GREAT LAKES INDIAN FISH AND WILDLIFE COMMISSION

January 31, 2017

Thank you for the opportunity to comment on the draft NPDES permit for the US Steel Minntac facility. These comments follow up on, and expand on, my email of December 23rd, 2016 and represent GLIFWC staff comments on the proposed permit and associated Fact Sheet.

Figure 6. Figure 2 of CRA report titled: "Estimate of Time of Travel between the Tailings Basin and the Twin Lakes Minntac Tailings Basin, United States Steel Corporation, Mountain Iron, Minnesota. July 11, 2013."

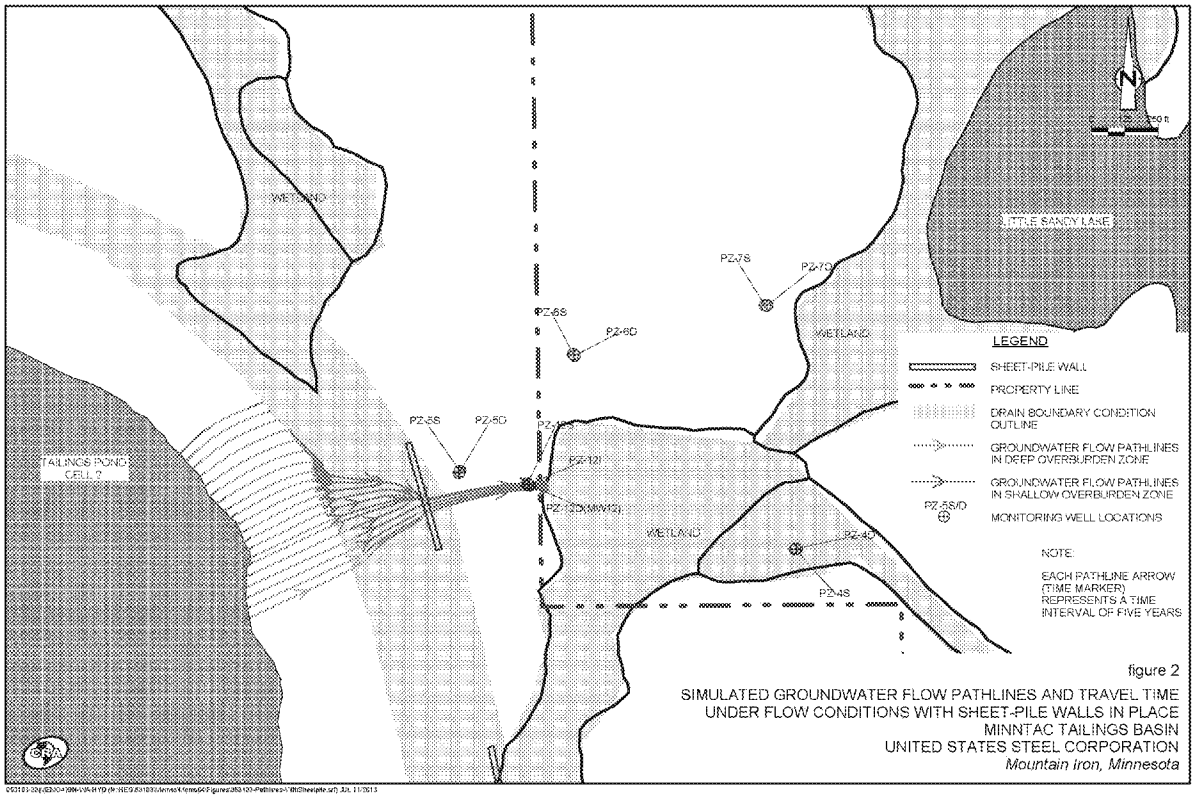
The portion of the Sand River between the Minntac tailings basin and Little Sandy Lake is mapped as "Protected (i.e. Public) Water" by the Minnesota DNR: (http://www.dnr.state.mn.us/waters/watermgmt_section/pwi/maps_ne.html) and is listed on page 50 of the St. Louis Co. Protected Waters: (http://www.dnr.state.mn.us/waters/watermgmt_section/pwi/download_lists.html and Attachment 1). It is listed as originating in section 15 (T59, R18) near Co. Hwy. 568 before flowing into the Sandy Lakes. While County Hwy. 568 has been flooded out by the tailings basin for many years, the road's footprint is still visible in aerial photographs, as is the channel of this section of the Sand River (Figure 5).

Figure 7. USGS topographic map published in 1951, based on aerial photos from 1947, showing the origin of the upper Sand River in a wetland that is currently covered by the Minntac tailings basin. County Hwy. 568, which is no longer passable, is visible just west of Admiral Lake.

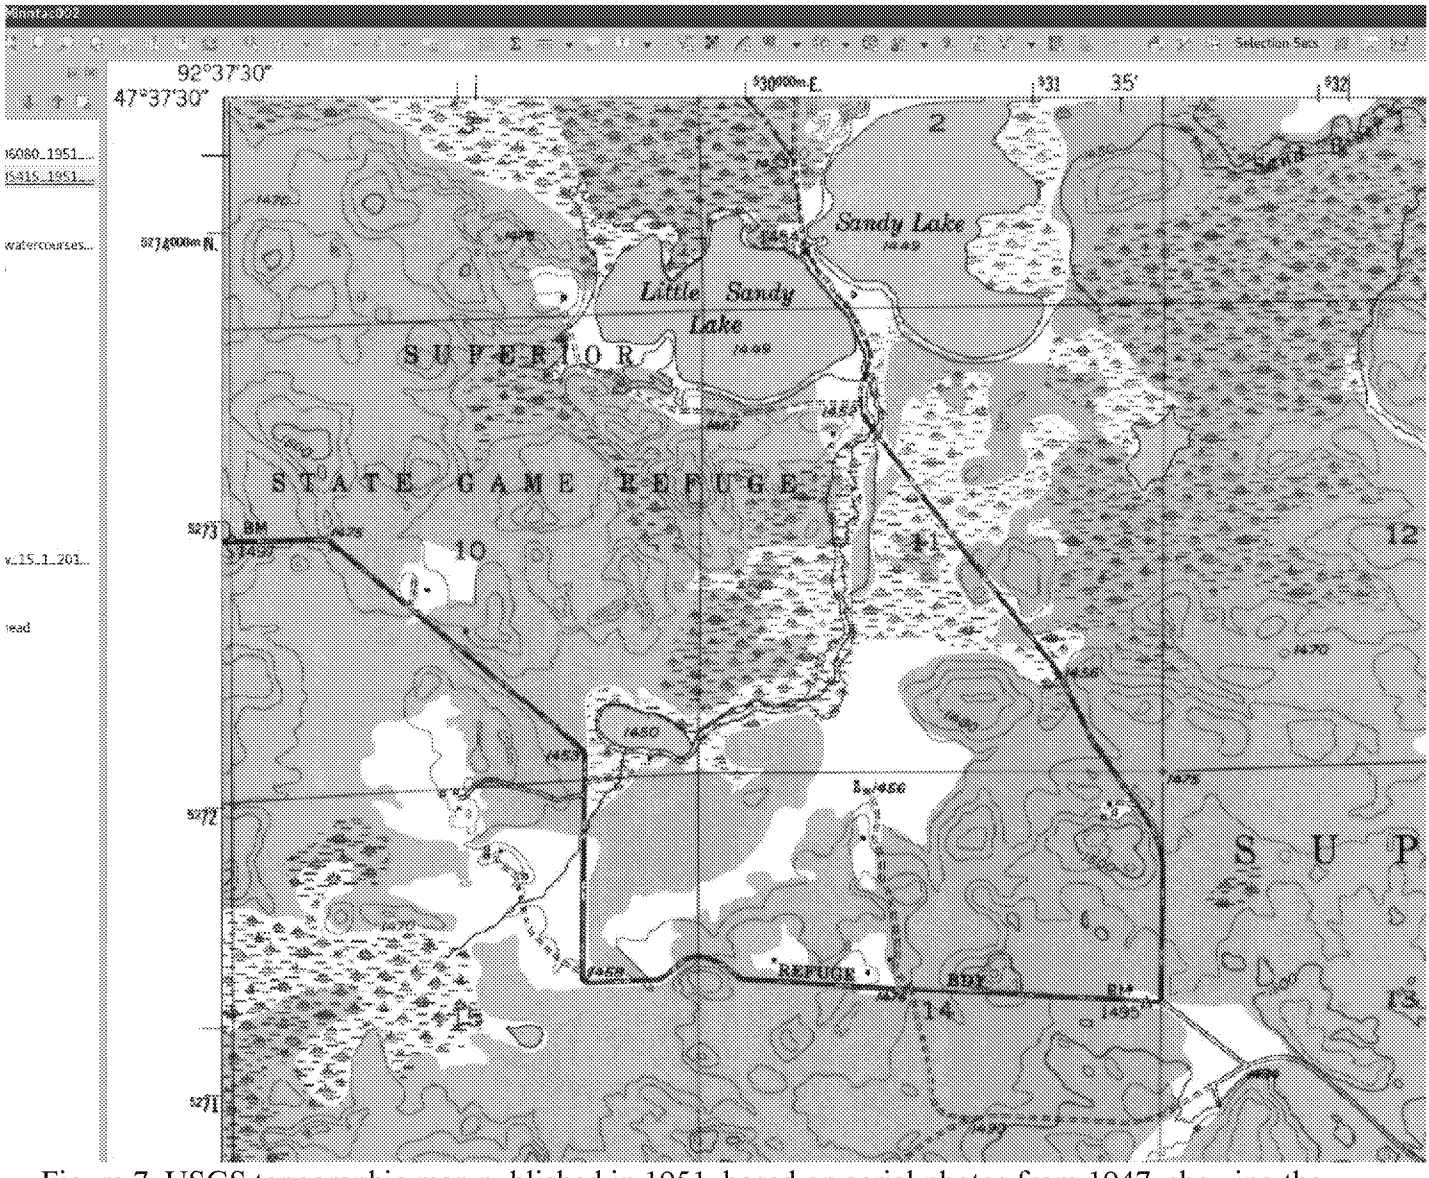
The section of Sand River flowing from the basin to Admiral Lake, and Admiral Lake itself, are represented as perennial water bodies on USGS topographic maps at least as far back as 1951 (Figure 7). While the very upper reaches of the Sand River were covered with tailings in the 1960s and '70s, the river downstream of the basin remains on state and federal maps of the area. The most recent Minnesota GIS data of state Protected/Public waters (https://gisdata.mn.gov/dataset/water-mn-public-waters) shows the upper Sand River as originating at the toe of the Minntac tailings basin. The latest (2016) USGS topographic map of the area continues to show the upper reaches of the Sand River and Admiral Lake as perennial water bodies (Figure 8).
